CITY OF PERRIS

MEMORANDUM

Subject: TTM 38071 (TTM21-05032), GPA21-05040, ZC21-05039 – Conditions of Approval –
Proposal to amend the General Plan Land Use and Zoning designation of approximately 31.1 acres to facilitate 192 single-family lots of subdivision with 7 letter lots, located on northeast corner of Ramona Expressway and Evans Road.

Figure 1 – Plan and Profile Views of SFB Basin

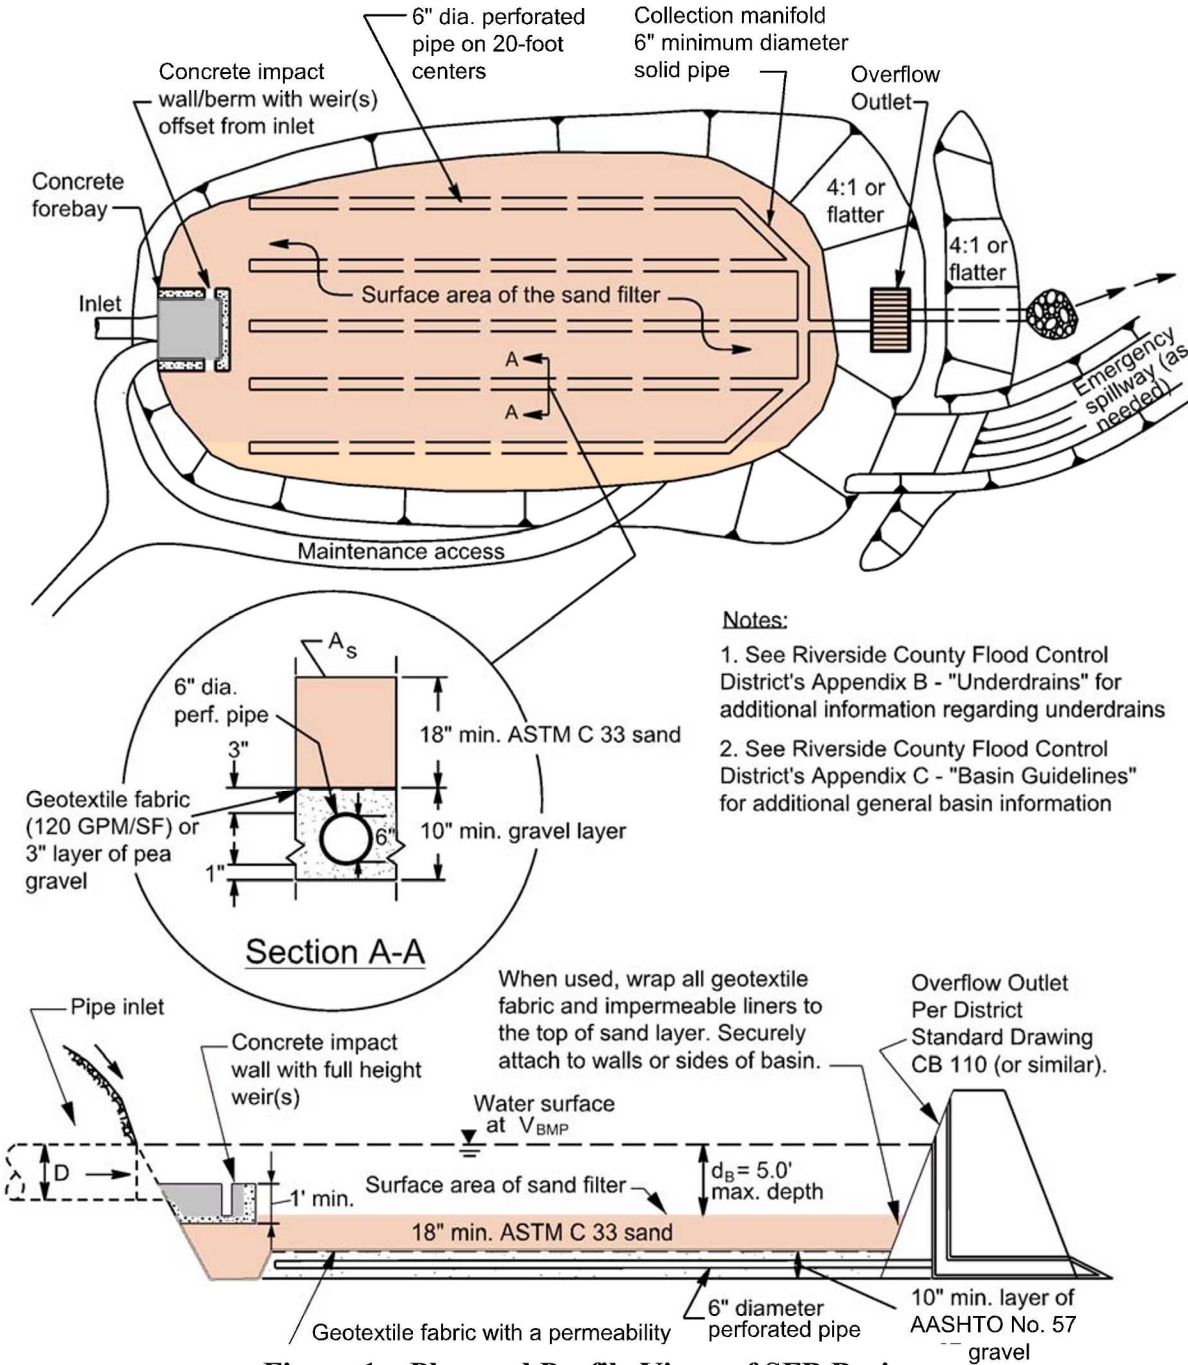
DEVELOPER TO PROVIDE GRAVEL IN LIEU OF SAND. CITY COMMENTS 1/11/2022.
